# UNITED STATES PATENT AND TRADEMARK OFFICE

APPLICATION NO.	FILING DATE	FIRST NAMED INVENTOR	ATTORNEY DOCKET NO.	CONFIRMATION NO.
10/814,564	03/31/2004	Nico Cocchiarella	SHPR-01362US2	6892
7590		11/16/2005	EXAMINER	
Sheldon R. Meyer		CHOI, STEPHEN		
FLIESLER MEYER LLP		ART UNIT		
Fourth Floor		PAPER NUMBER		
Four Embarcadero Center		3724		
San Francisco, CA 94111-4156		DATE MAILED: 11/16/2005

# Office Action Summary

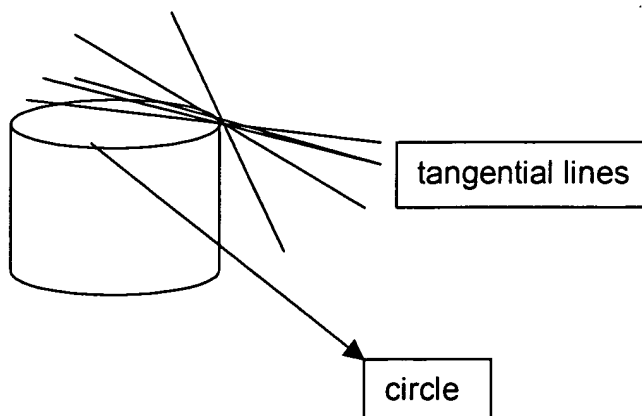
- a) a housing (e.g., 20);
- b) a motor (e.g., 70);
- c) a blade holder (e.g., at 180);
- d) at least one cutter blade including a first cutter portion, a second cutter portion, and a rounded third cutter portion ( Fig. 3A) wherein the second cutter portion forms an angle with the first cutter portion (col. 3, lines 20-22).

Regarding claim 9, a second angle (the second portion (at 190) forms an angle with a line tangential to a circle traced by the cutter blade). Regarding claim 10, there are an infinite number of lines that are tangential to the circle traced by the cutter blade that forms an angle (e.g.,  $2.2^\circ$ ) with portions of the second portion (see Figure below).
